January 27, 2000
RC-00-0025

Subject: VIRGIL C. SUMMER NUCLEAR STATION
DOCKET NO. 50/395
TECHNICAL SPECIFICATION AMENDMENT REQUEST
TSP 99-0160 - SPENT FUEL POOL - K_{∞}

SCE&G -- EXPLANATION OF CHANGES

SAFETY EVALUATION
FOR REVISING SPENT FUEL STORAGE REQUIREMENTS IN
THE VIRGIL C. SUMMER NUCLEAR STATION
TECHNICAL SPECIFICATIONS

SOUTH CAROLINA ELECTRIC & GAS CO.
VIRGIL C. SUMMER NUCLEAR STATION
Region 1 Minimum
IFBA Requirements
FIGURE 5.6-1

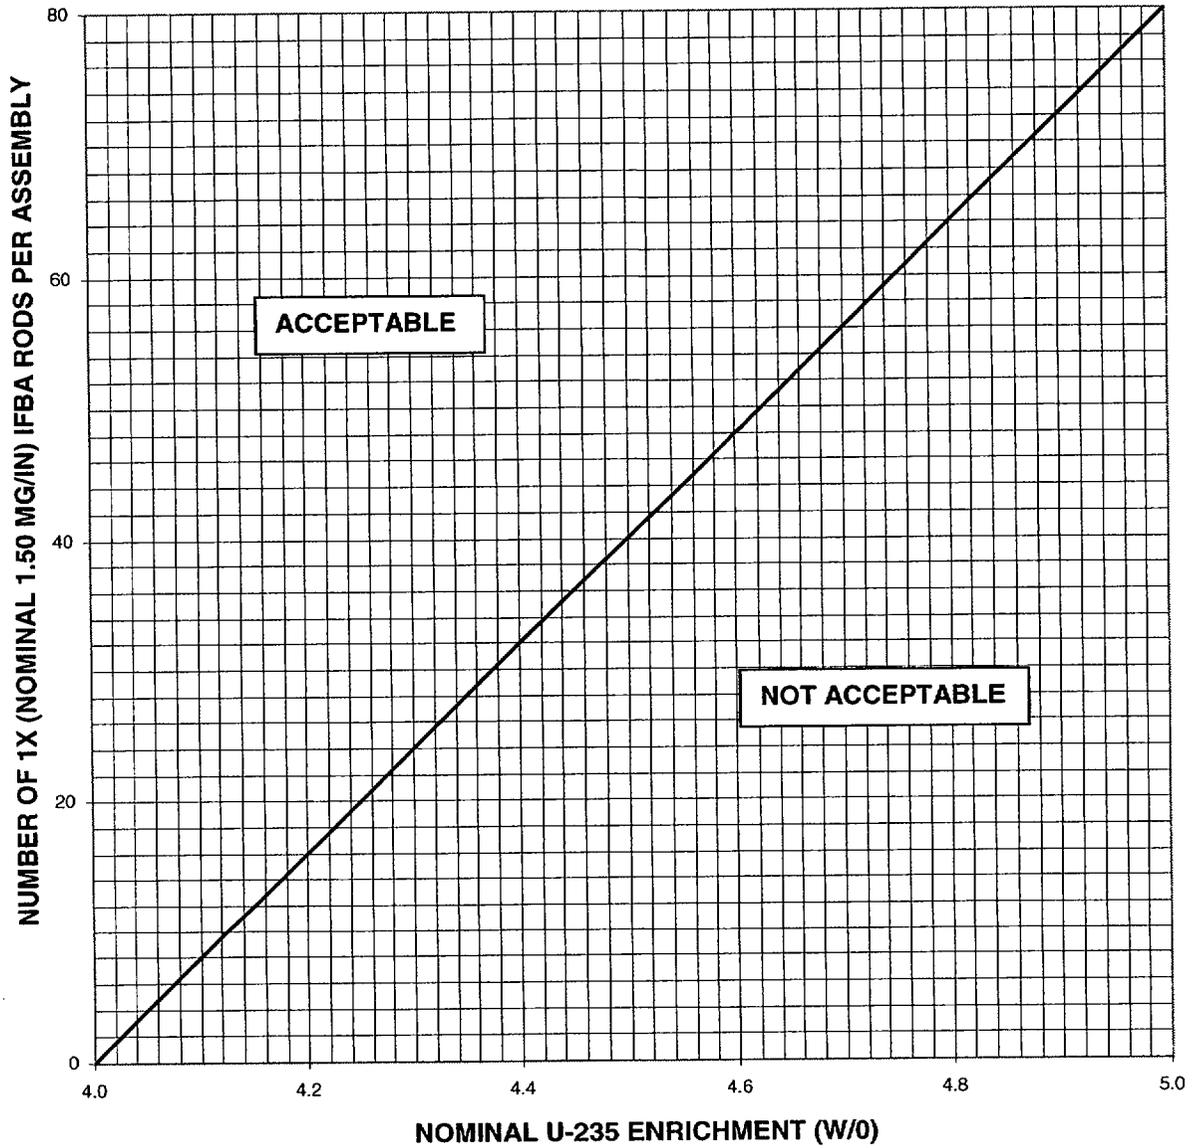
The proposed changes will revise the Spent Fuel Pool reactivity limit requirement by removing the value for K_{∞} from Specification 5.6.1.1 and replacing it with a figure of Integral Fuel Burnable Absorbers (IFBA) rods versus nominal Uranium-235 enrichment. The proposed change will also delete the value for K_{∞} from Specification 5.6.1.2, since IFBA credit is not considered or required in the new fuel storage criticality analysis.

Page	Affected Section	Bar #	Description	Reason
5-7	5.6.1.1	1	Deleted reference to K_{∞} and insert reference to Figure 5.6-1 and provide discussion on IFBA Boron loading versus number of IFBA rods	Utilizing different methodology for assuring licensing basis for spent fuel pool is maintained.
5-7	5.6.1.2	2	Deleting reference to K_{∞} and IFBAs	Utilizing different methodology for assuring licensing basis for spent fuel pool is maintained and no credit for IFBAs in new fuel racks is in the new fuel storage criticality analysis.
5-8 (NEW)	Figure 5.6-1	1	Inserting new figure of IFBA rods versus fuel enrichment as Page 5-8	Utilizing different methodology for assuring licensing basis for spent fuel pool is maintained.
5-7a	5.6.2 and 5.7	1	Renumbering page to Page 5-9	Allows figure 5.6-1 to be next to Section 5.6.1.1
5-8	Table 5.7-1	1	Renumbering page to Page 5-10	Allows figure 5.6-1 to be next to Section 5.6.1.1

2. A ~~maximum~~ nominal enrichment of 5.0 weight percent U-235 with ~~sufficient integral fuel burnable absorbers, such that the maximum reference fuel assembly K_{eff} is less than or equal to 1.460 at 68°F.~~ ←

as shown on
Figure 5.6-1

The Integral Fuel Burnable Absorbers (IFBA) rod requirements shown in Figure 5.6-1 are based on a nominal IFBA linear B^{10} loading of 1.50 mg- B^{10} /inch (1.0X). For higher IFBA loadings up to 3.00 mg- B^{10} /inch (2.0X), the required number of IFBA rods may be reduced by the ratio of the increased B^{10} loading to the nominal 1.50 mg- B^{10} /inch loading. The poison length of the IFBA rods is greater than or equal to 108 inches.

2. A nominal enrichment of 5.0 weight percent U-235 with a minimum number of integral fuel burnable absorbers as shown on Figure 5.6-1. The Integral Fuel Burnable Absorbers (IFBA) rod requirements shown in Figure 5.6-1 are based on a nominal IFBA linear B^{10} loading of 1.50 mg- B^{10} /inch (1.0X). For higher IFBA loadings up to 3.00 mg- B^{10} /inch (2.0X), the required number of IFBA rods may be reduced by the ratio of the increased B^{10} loading to the nominal 1.50 mg- B^{10} /inch loading. The poison length of the IFBA rods is greater than or equal to 108 inches.
